## PHILCO MODEL: C-5690(HR)

### SCHEMATIC PHILCO MODEL C-5690HR

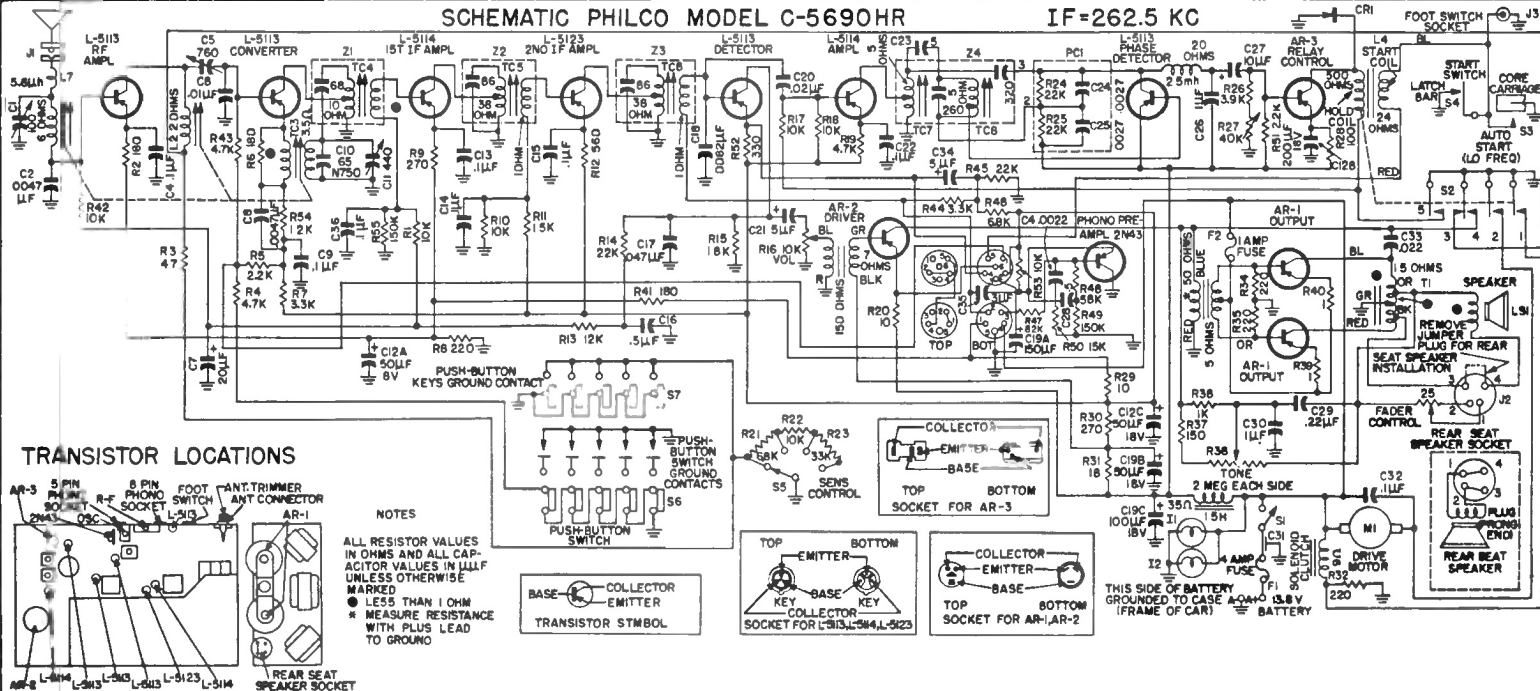
Resistor R55 was changed from 150,000 ohms to 220,000 ohms, part No. 66-4228340.

Resistor R45 was changed from 22,000 ohms to 82,000 ohms, part No. 66-3828340.

A 47-ohm, 1/2-watt resistor, part No. 66-0478340, was added between emitter detector transistor L-5113 and the junction of R52 C35. A .1-ufd capacitor, part No. 30-1260, was added between the emitter of Detector Transistor L-5113 and ground.

Resistor R15, was changed from 1.8K to 2.7K  $\pm 10\%$ , part No. 66-2278340.

Resistor R29 was changed from 10 ohm  $\pm 5\%$  to 8.2 ohms  $\pm 5\%$ , part No. 66-9823260.

Resistor R23 was changed from 33,000 ohms to 10,000 ohms, part No. 66-1038340.
